Attachment A5

Proponent's Draft DCP Amendment

Site Specific Development Controls – Green Square Sites 8A and 8B Draft amendments to Green Square Town Centre Development Control Plan 2012

Figure 3.28 Through-Site Link Sites 8A and 8B – Section
 (New graphic below proposed to be inserted)

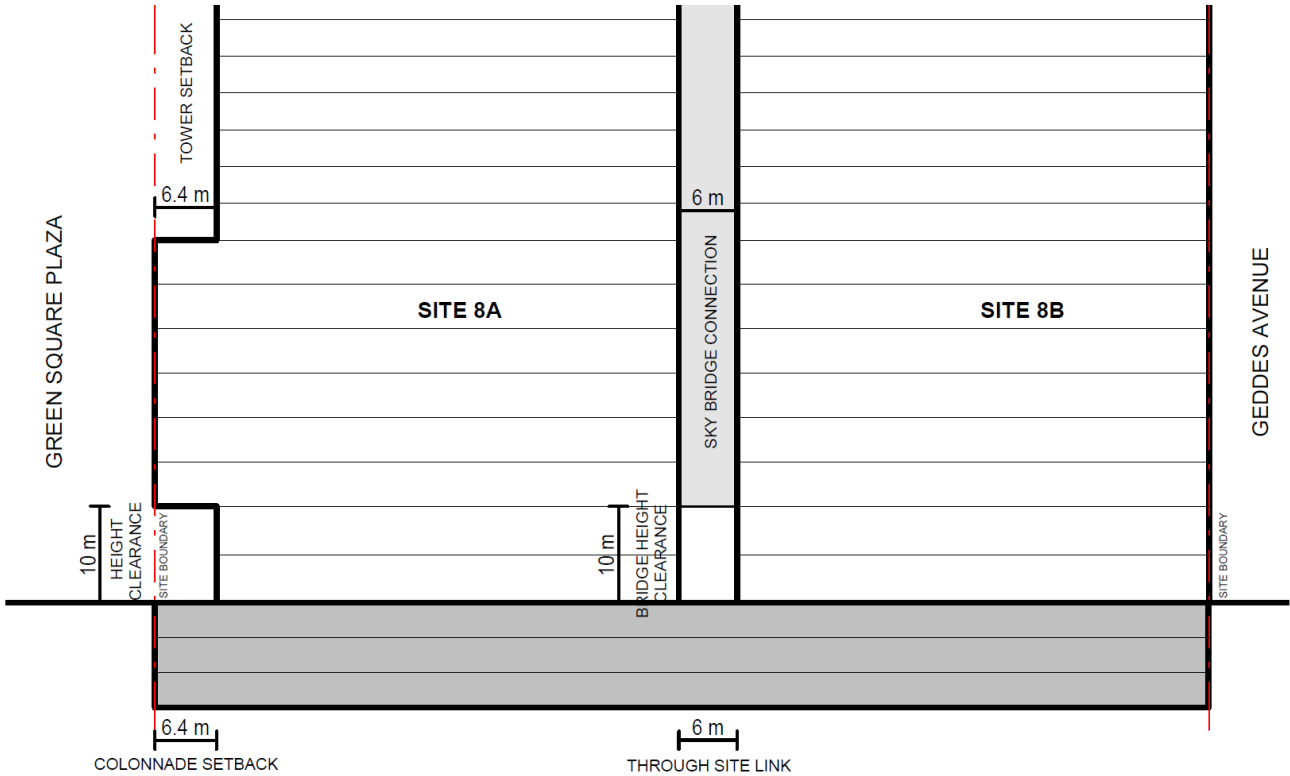
- 10) Between sites 8A and 8B, ~~3m~~ **20m** wide ~~fully-clear~~ glazed sky bridges may connect the development sites at levels greater than 10m above ground level, **in accordance with Figure 3.27: Through-site links and arcades, Figure 3.28: Through-Site Link Sites 8A and 8B – Section and Figure 3.29: Through-Site Link Sites 8A and 8B – Plan**
